**BID-TIME ADDENDUM # 1**

December 2, 2022

Murrieta Elementary School  
Murrieta Valley Unified School District  
App. # 04-119432, File # 33-32

DLR Group | BakerNowicki Design Studio  
731 Ninth Avenue, Suite A  
San Diego, CA 92101

# 4017 MURRIETA ES - SITE UTILIZATION PLAN 12/1/2022

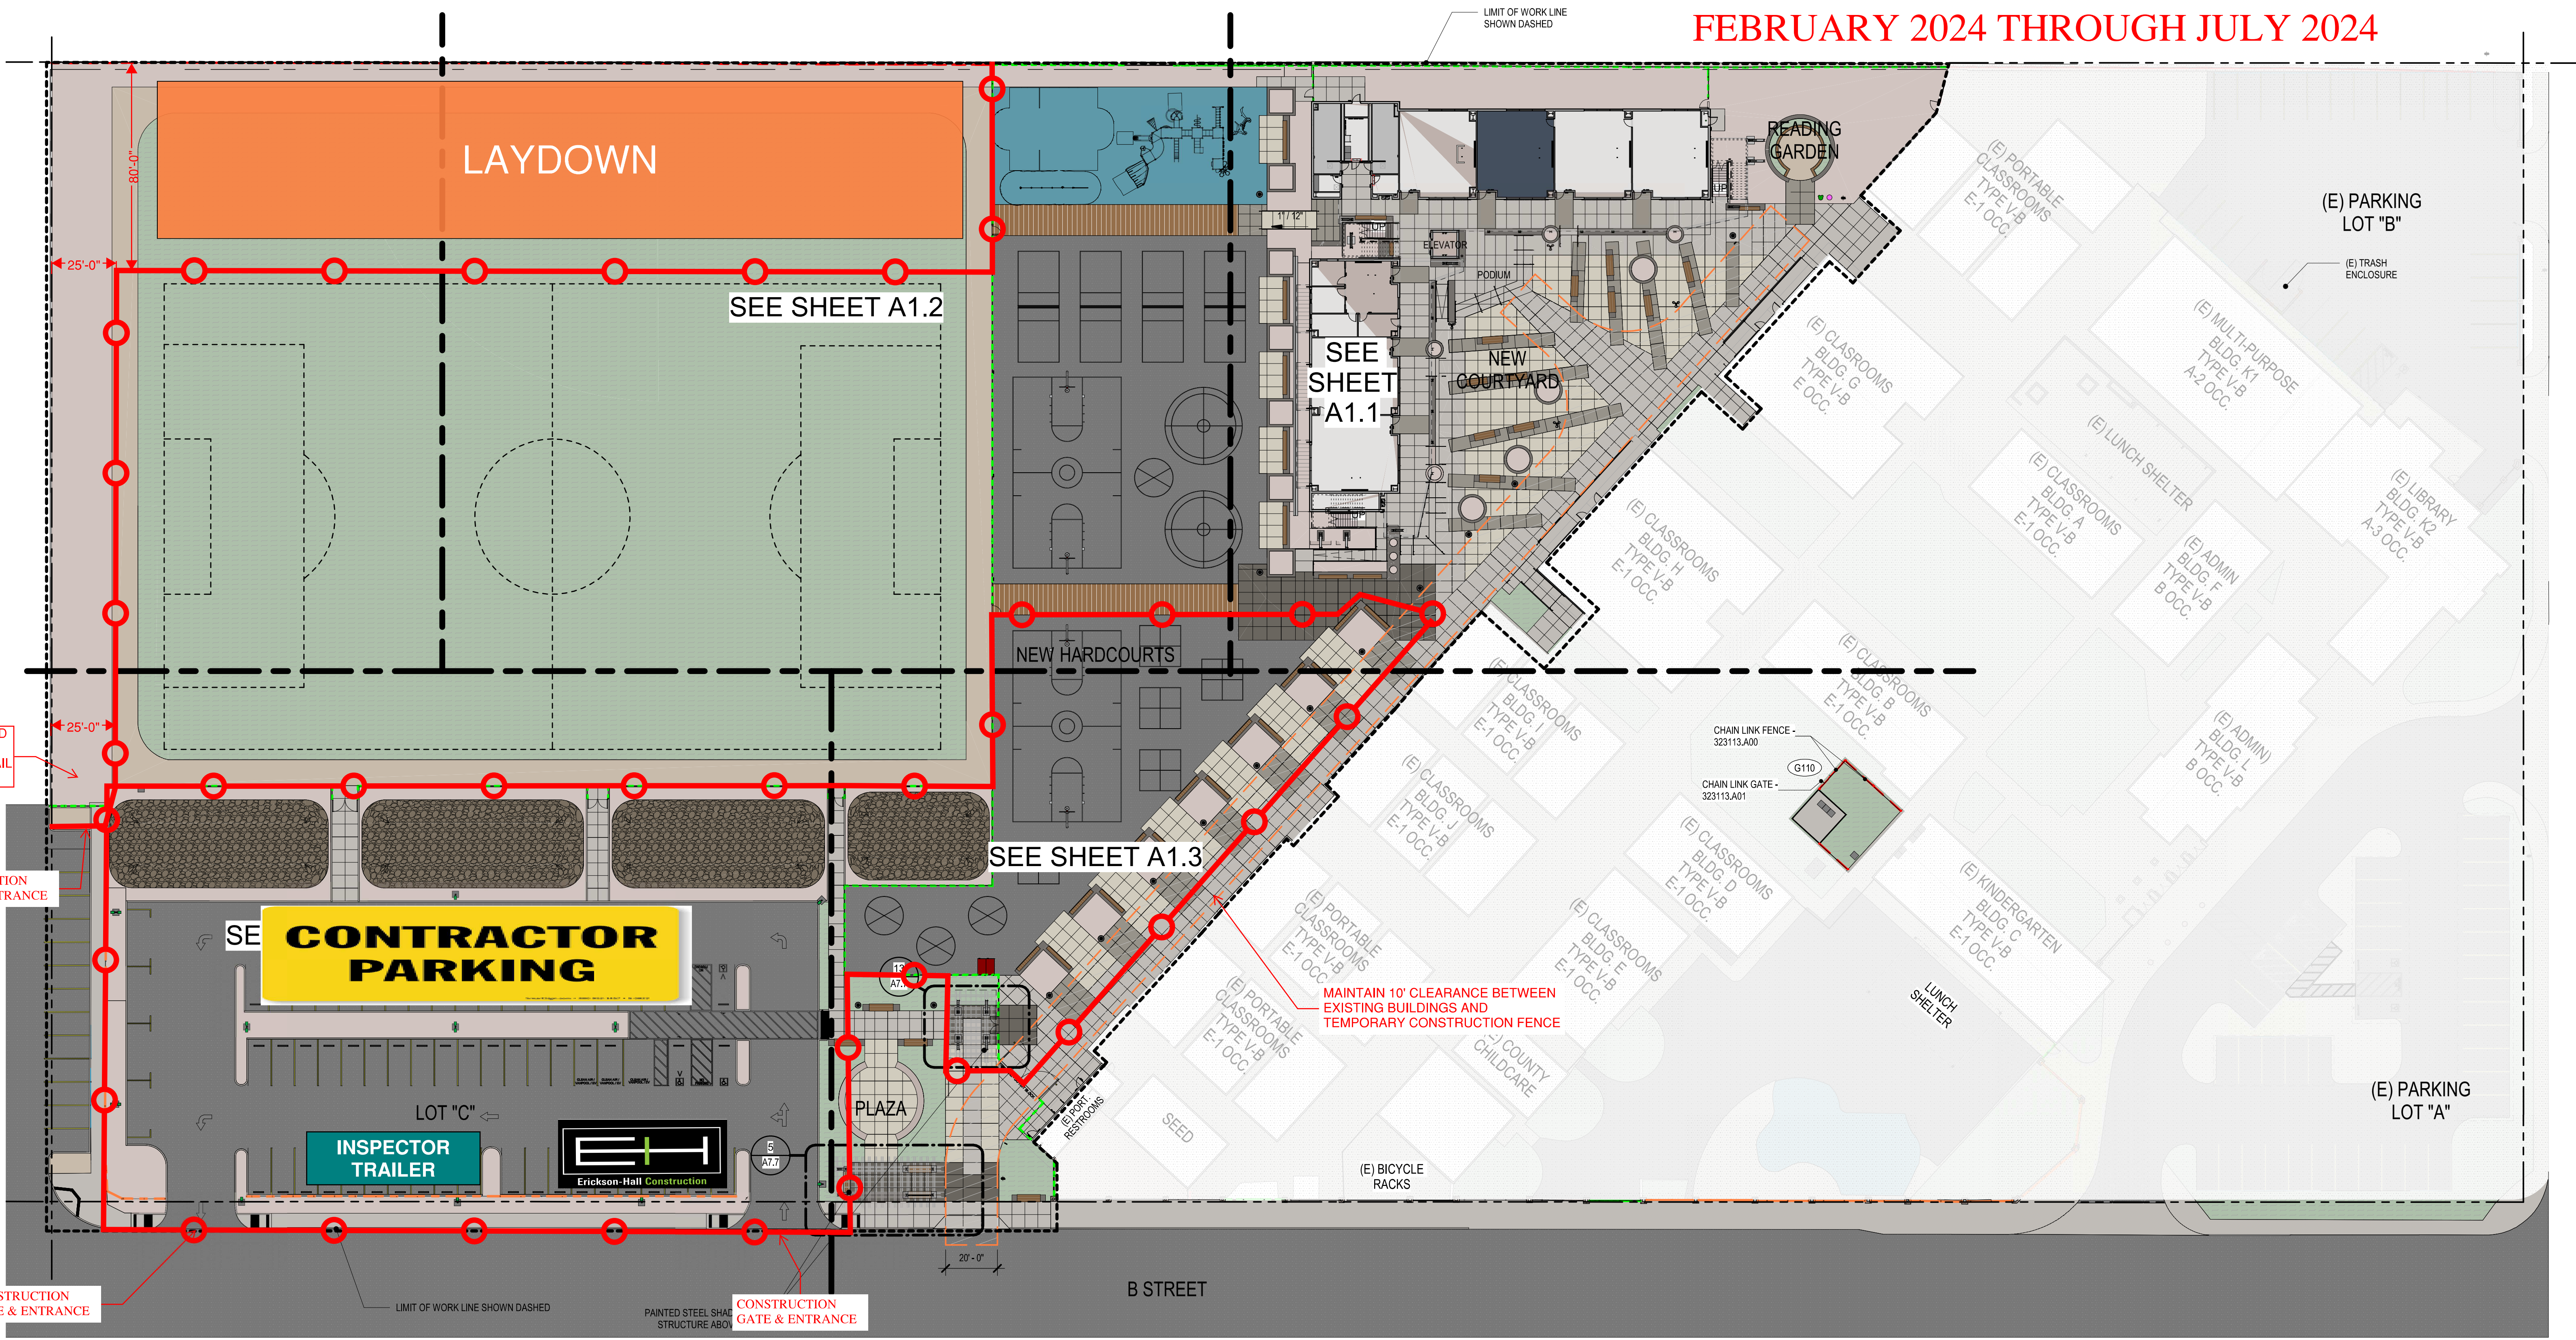
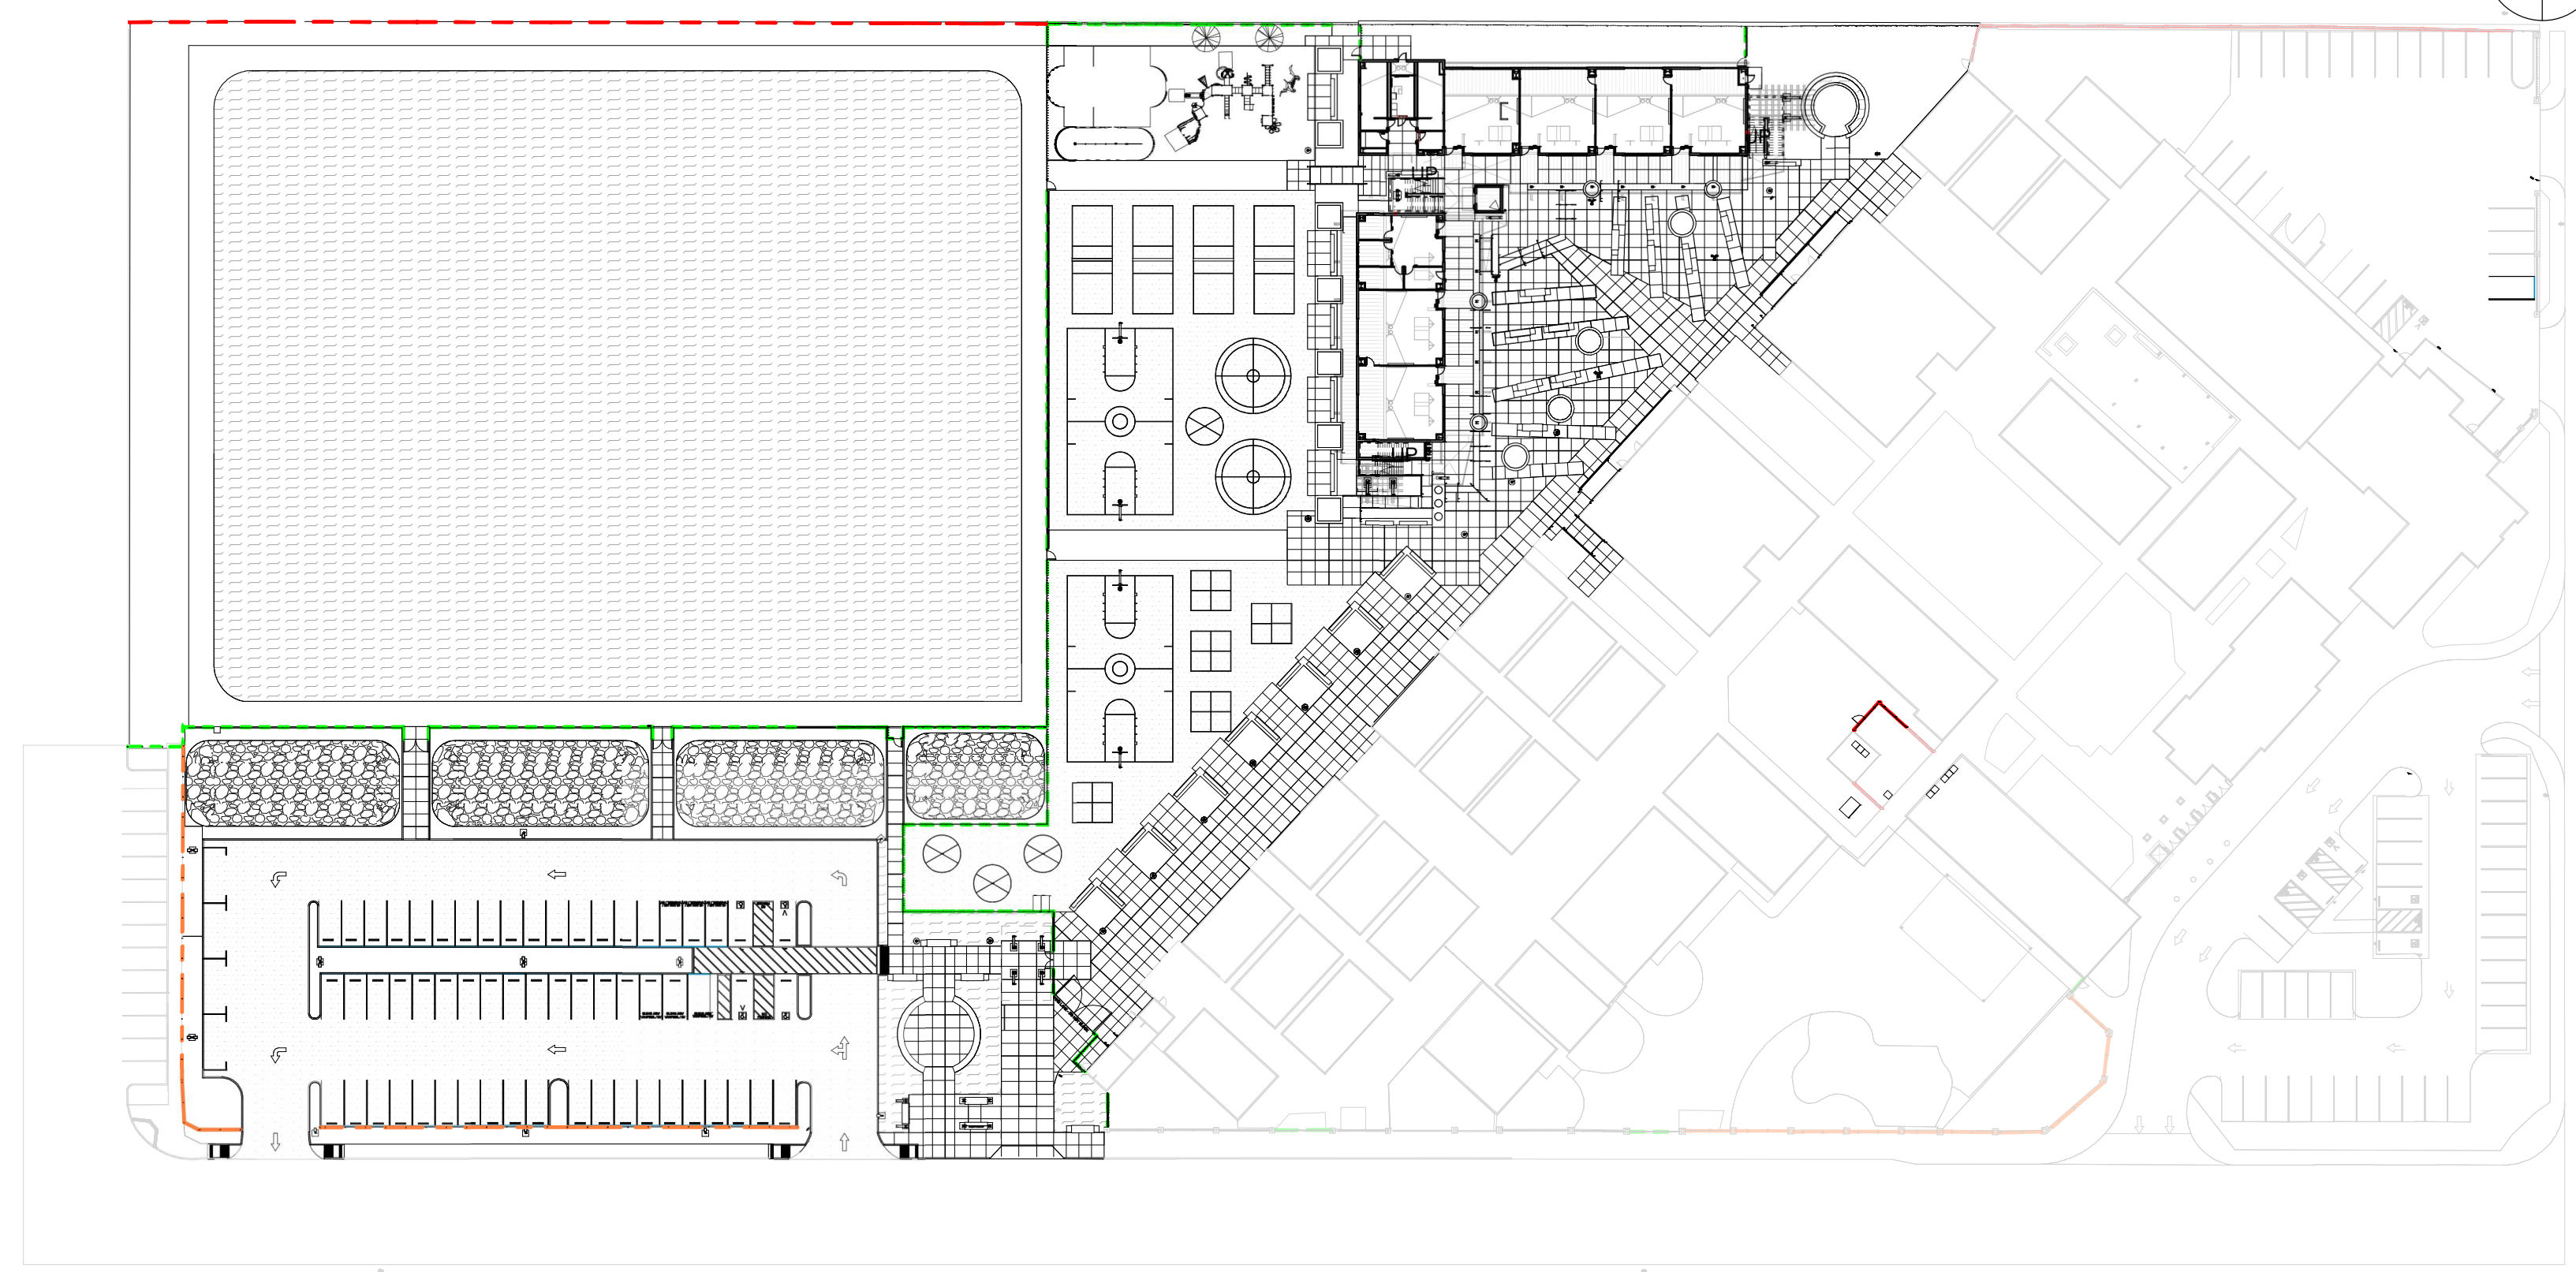
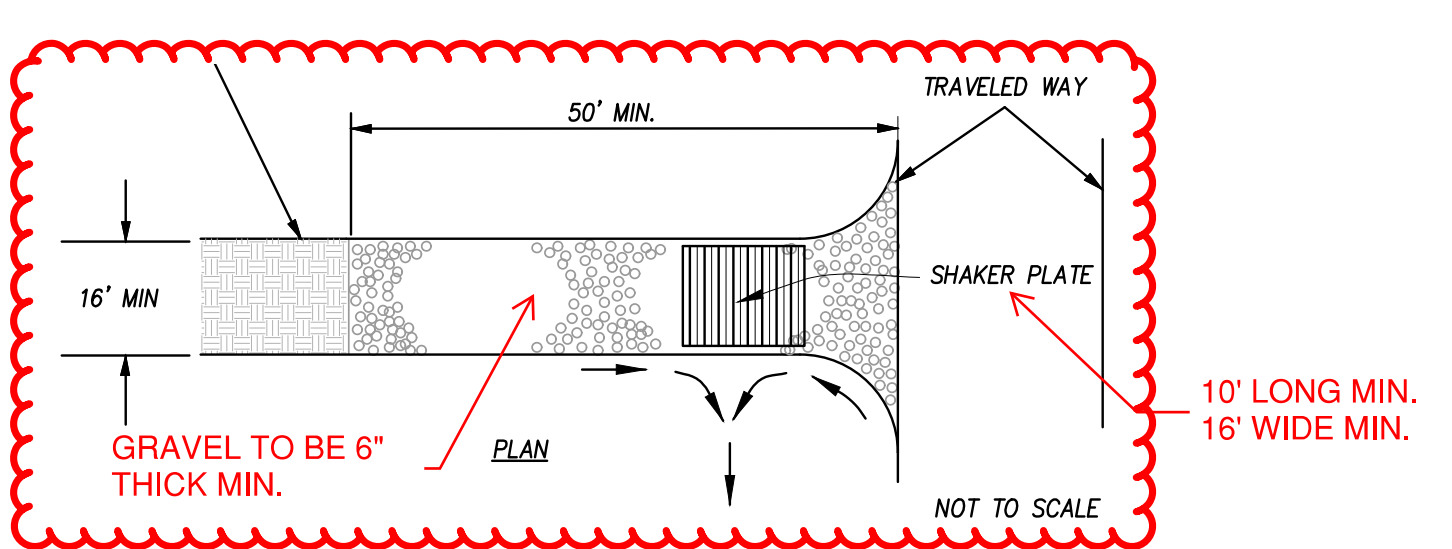
PROVIDE GRAVEL AND RATTLE PLATES FOR ENTRANCE PER DETAIL SHOWN BELOW

MAINTAIN 10' CLEARANCE BETWEEN EXISTING BUILDINGS AND TEMPORARY CONSTRUCTION FENCE

DRAWING  
AD1 - SWPCP  
EXHIBIT

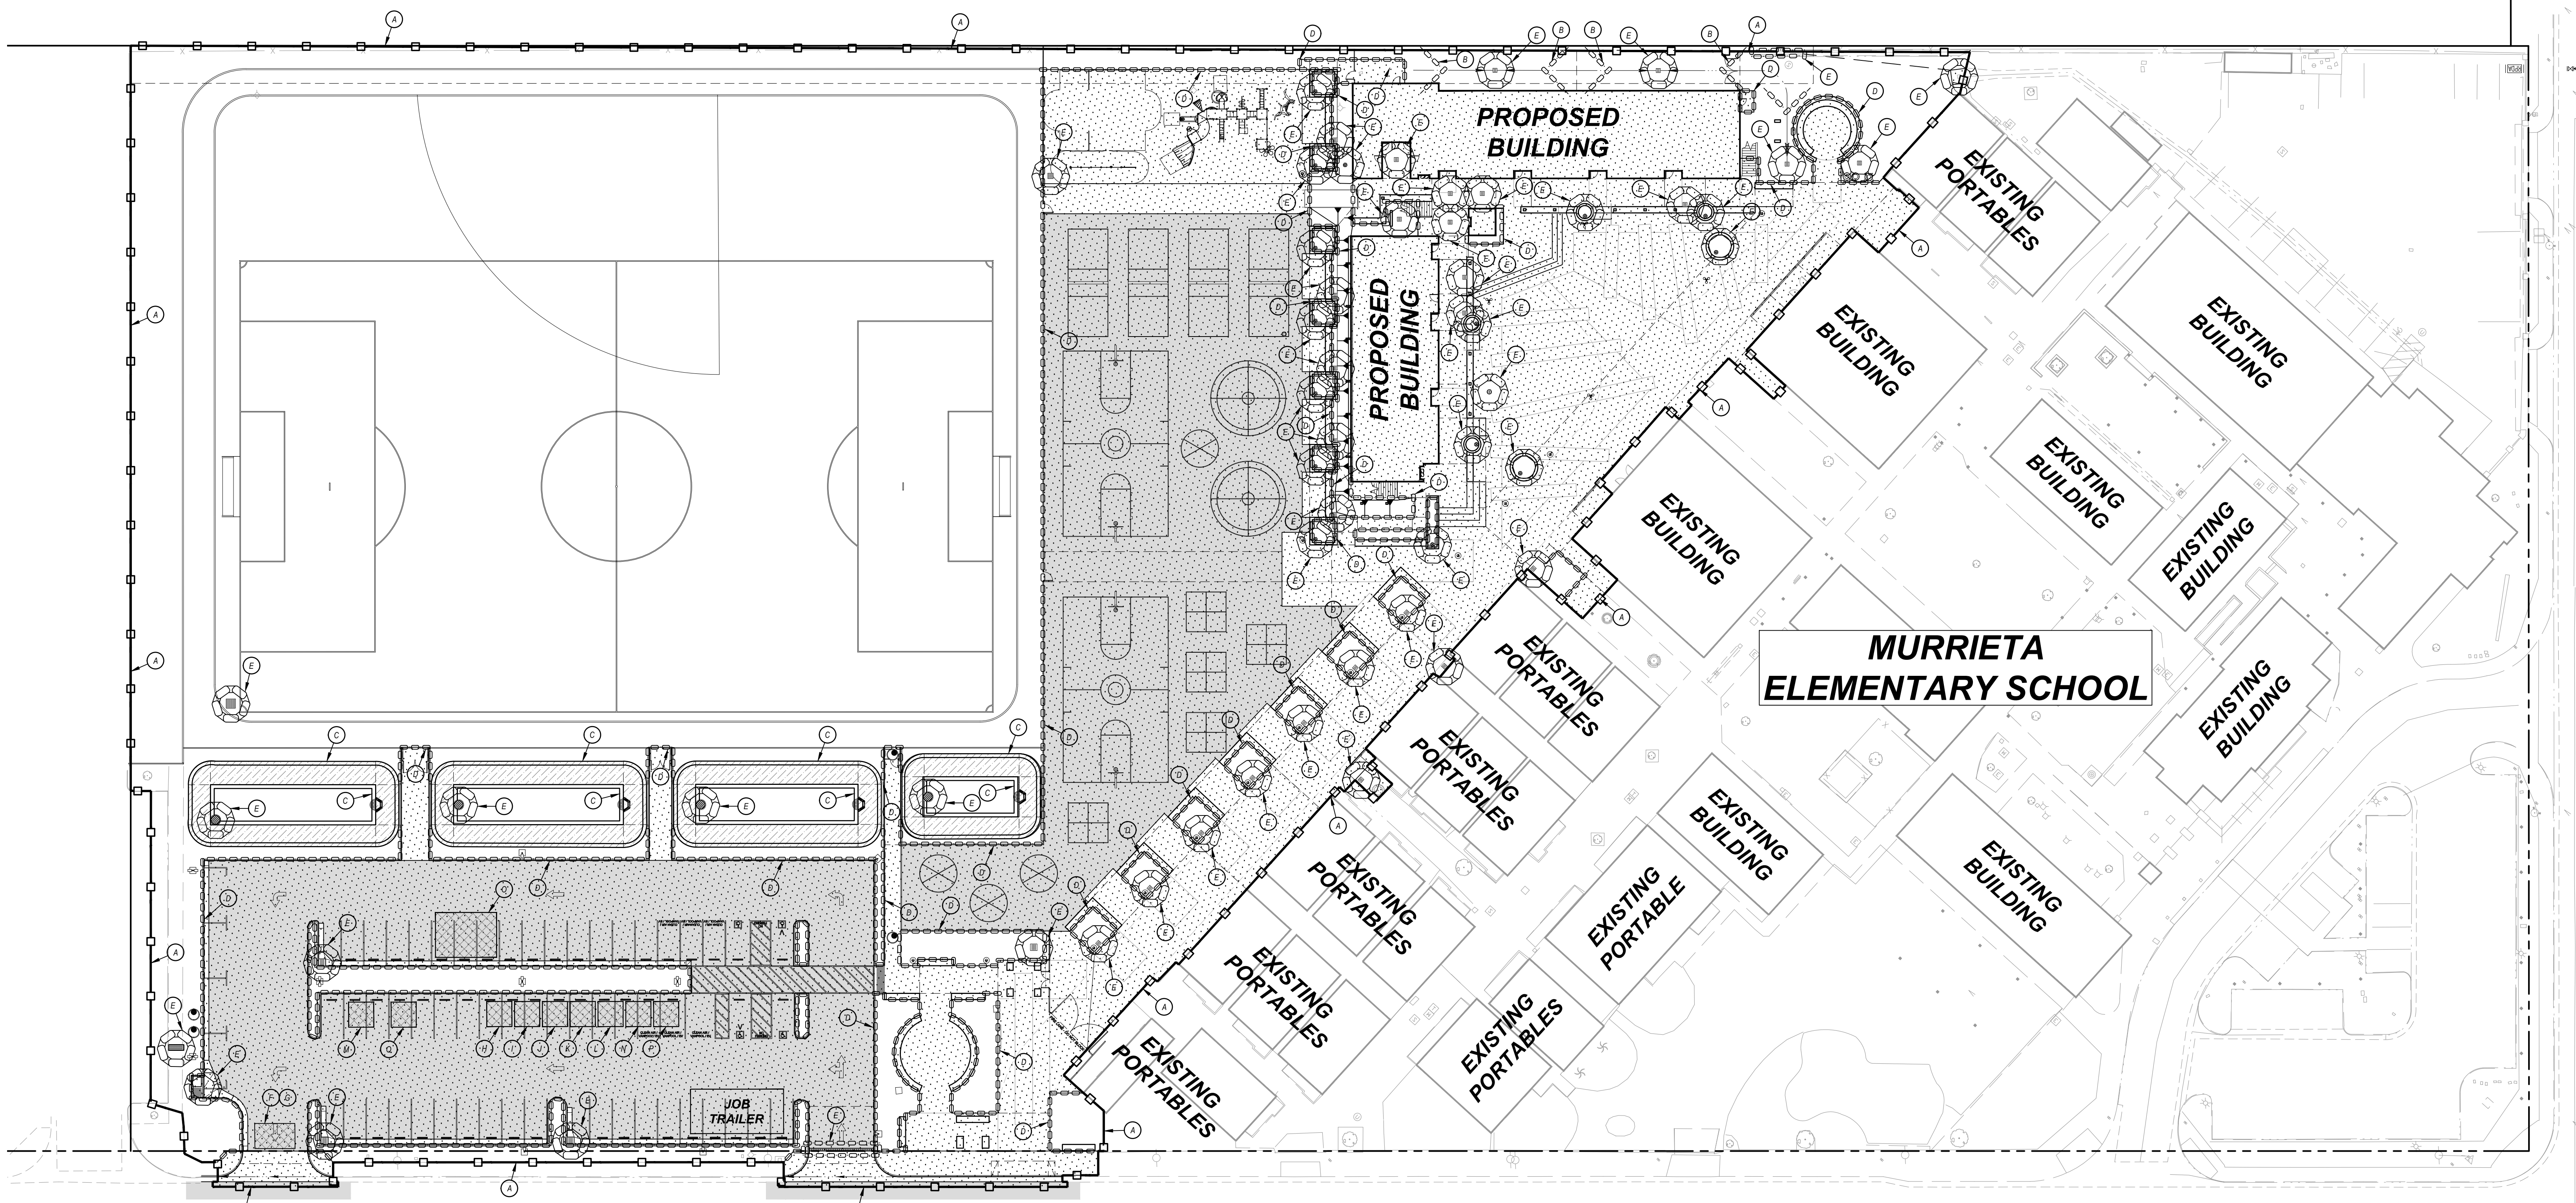
- A. Schedule was not originally included in contract documents, but is incorporated into the contract documents via this bid-time addendum 01. See attachments section for preliminary construction schedule and phasing plan.
- B. Site utilization plan is also attached and therefore incorporated into the contract documents. Information included in the site utilization plan is as follows:
- a. Installation and relocation of temporary fencing, and construction gates per phasing of project to be included in BP#1. Whenever possible temporary fencing will need to be secured to the ground via stakes in lieu of sand bags. Coordinate with CM Superintendent for direction on when and where this condition will occur.
